Hadley Smart Valve – Raising Suspension – Update

Fig. 1, Hadley SmartValve

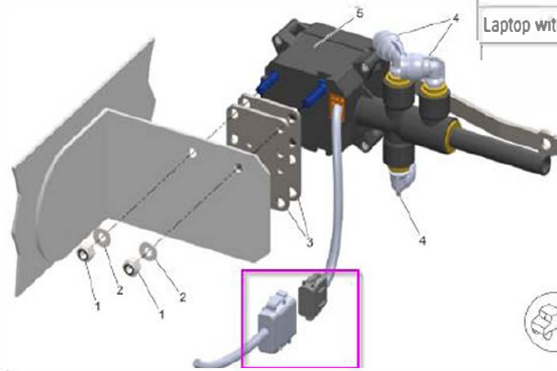
Hadley Smart Valve causing rear suspension ride height to inflate to max

Software bug causing unintended raised suspension while in bobtail mode

Current Field Fix: Replace valve with latest p/n **OR** Laptop + CAN cable firmware to locations w/ highest concentration of trucks (via connection @ highlighted)

Production Changeover Date: December 2025 (any parts received now are the latest version)
